QUALITY ASSURANCE -- NON-CONFORMANCE REPORT

Location: Changxing Island, Shanghai, PR China**Report No:** NCR-000877**Prime Contractor:** American Bridge/Fluor Enterprises, a JV**Date:** 27-Oct-2010**Submitting Contractor:** Zhenhua Port Machinery Company, Ltd (ZPMC), Changxing Island**NCR #:** ZPMC-0839**Type of problem:**

Reference Description: Repair of Backing Bars for CJP weld joints**Description of Non-Conformance:**

Subject: NCR No. ZPMC-0839

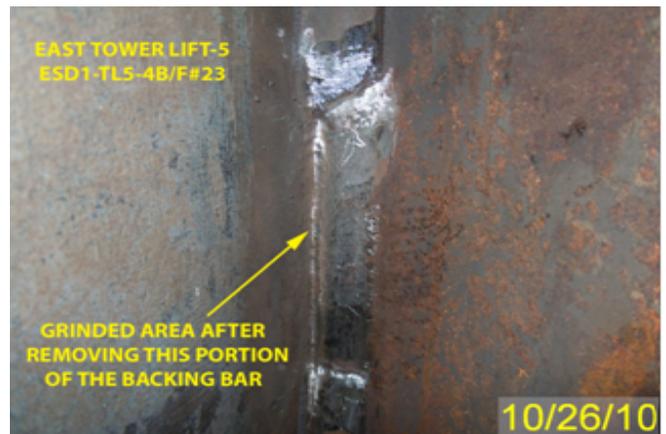
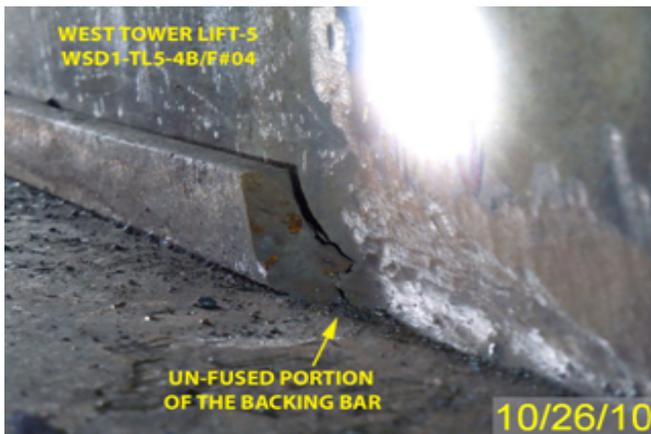
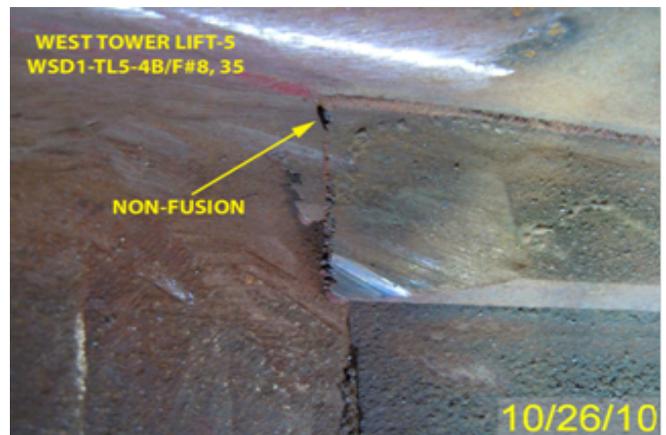
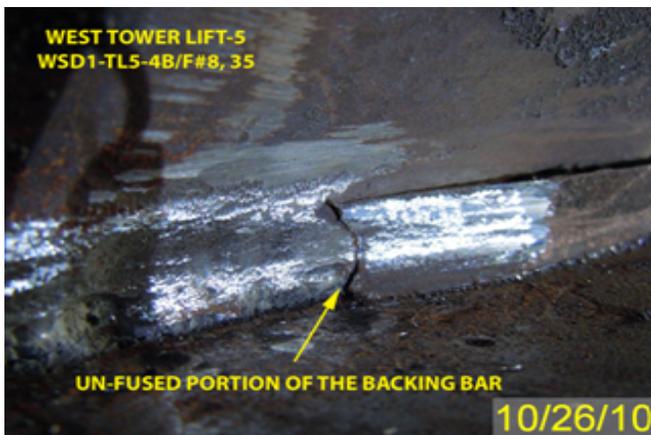
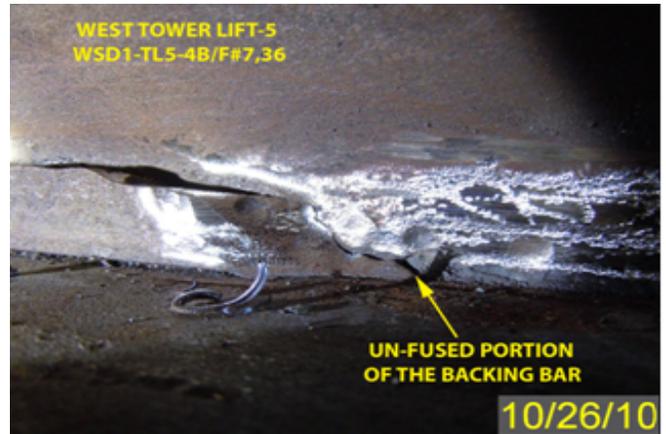
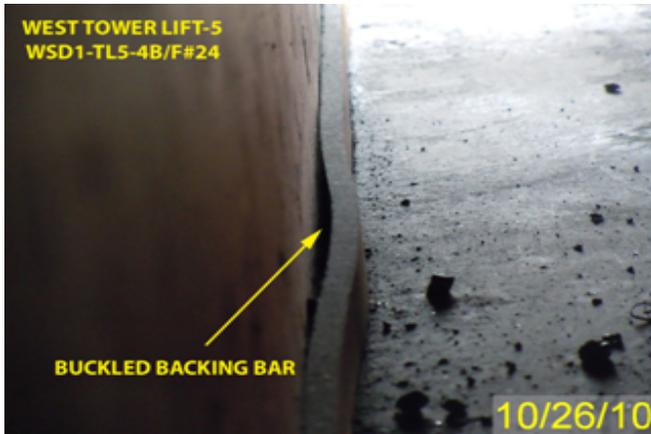
- 1) Non-Fused backing bar requires removal -joint -WSD1-TL5-4B/F#7,36
- 2) Non-Fused backing bar requires removal -joint-WSD1-TL5-4B/F#8,35
- 3) Buckled backing bar requires removal -joint-WSD1-TL5-4B/F#24
- 4) Non-Fused backing bar requires removal -joint-WSD1-TL5-4B/F#4

- 1) Area where backing bar has been removed requires back welding -joint ESD1-TL5-2B/F#23

-As per AWS D1.5 the RFI-002099R0 the groove welds made with steel backing shall have the weld metal thoroughly fused. The remaining ends of the backing bar shall be tapered in with and in depth at a slope no steeper than 1:2.5, as shown in the sketch attached with the referenced RFI.

Contractor will remove the backing bars in question, and repair the area as per Design's requirements ie. RFI-2099. Contractor will also provide NDT report to show the welds involved and also the repair areas are acceptable.

Contractor gouged off the defective backing bars, and ground the areas as per RFI 2099 requirements. NDT reports were provided proving the welds involved and the repair areas were free of defects. Considering the access difficults, and facilitate fabrication the repair has been accepted by Construction as "fit for purpose."

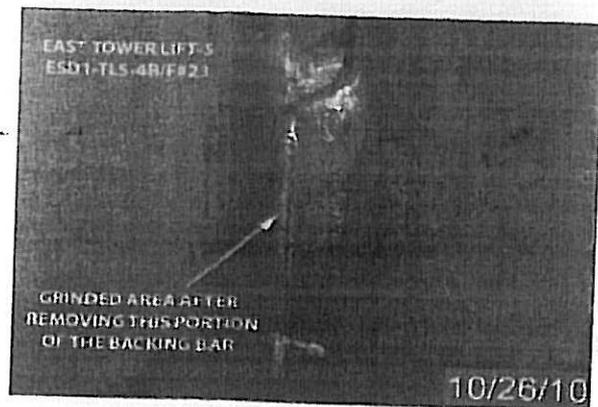
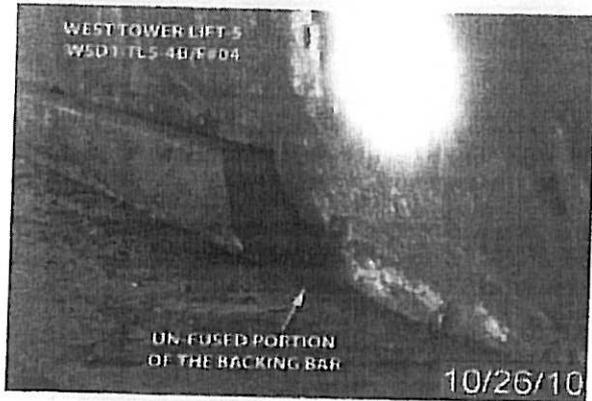
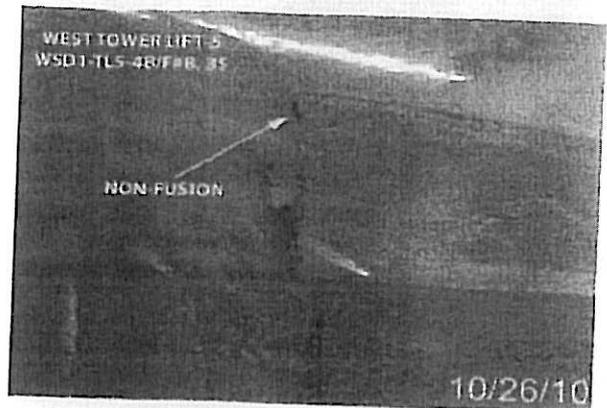
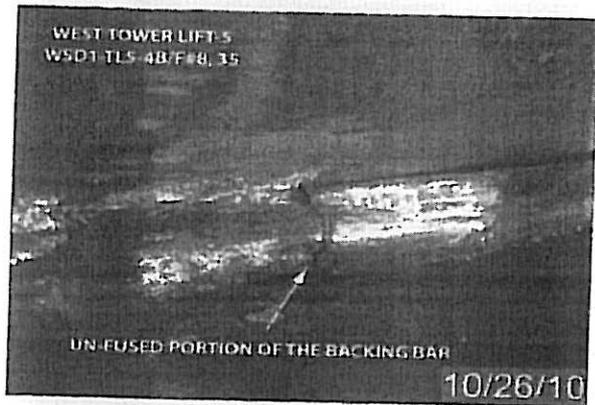
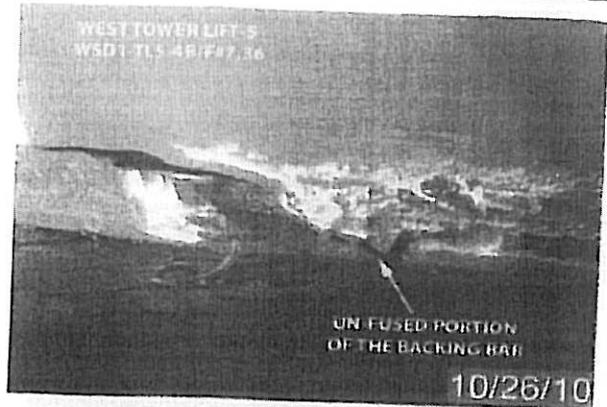
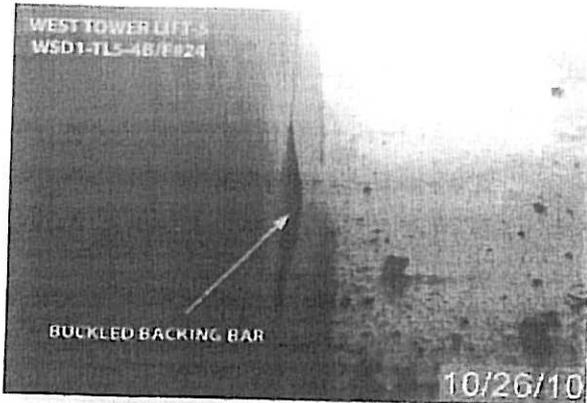
- 1) Non-Fused backing bar requires removal -joint -WSD1-TL5-4B/F#7,36
- 2) Non-Fused backing bar requires removal -joint-WSD1-TL5-4B/F#8,35
- 3) Buckled backing bar requires removal -joint-WSD1-TL5-4B/F#24
- 4) Non-Fused backing bar requires removal -joint-WSD1-TL5-4B/F#4

- 1) Area where backing bar has been removed requires back welding -joint ESD1-TL5-2B/F#23

-As per AWS D1.5 the RFI-002099R0 the groove welds made with steel backing shall have the weld metal thoroughly fused. The remaining ends of the backing bar shall be tapered in with and in depth at a slope no steeper than 1:2.5, as shown in the sketch attached with the referenced RFI.

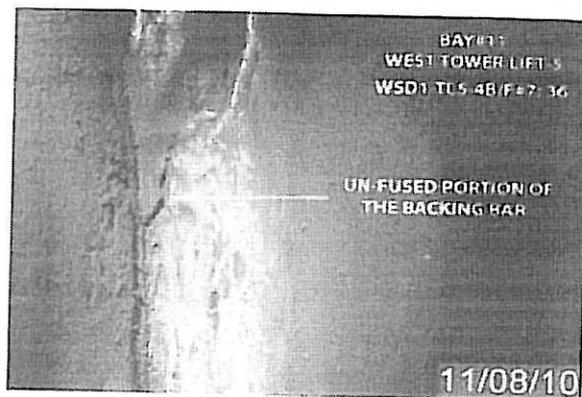
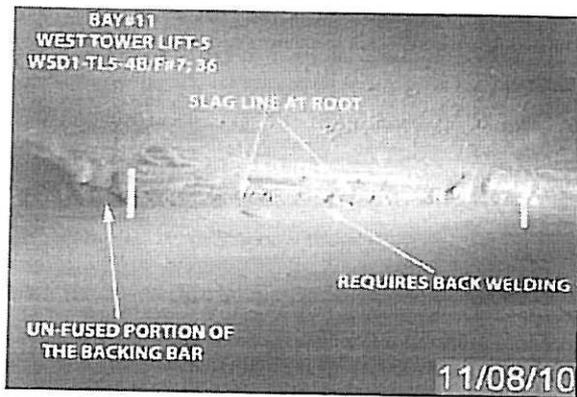
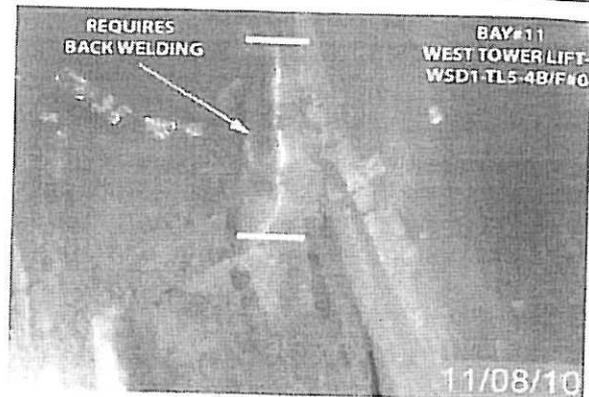
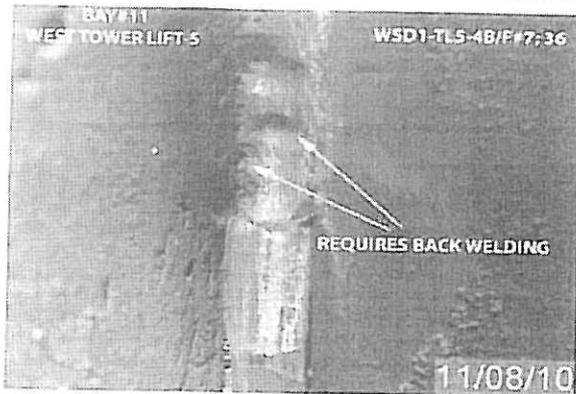
1) WSD1-TL5-4B/F#07; 36 – Non-fused backing bar has not been completely removed. There is a slag line at the entire visible root pass area.

2) WSD1-TL5-4B/F#04 – Root pass has been ground out to an average depth of 1.5mm. Back welding has not been performed.

With the intention to close the Non-Conformance Report, NCR#ZPMC-0839, ZPMC had submitted the Notice of Witness Inspection Number (NWIT) # 007275. This repaired area has been previously tested and accepted by ZPMC Quality Control (QC) personnel. ZPMC's QC personnel performed 100% VT and MT inspection of this area.

For further information, please see the attached pictures below.
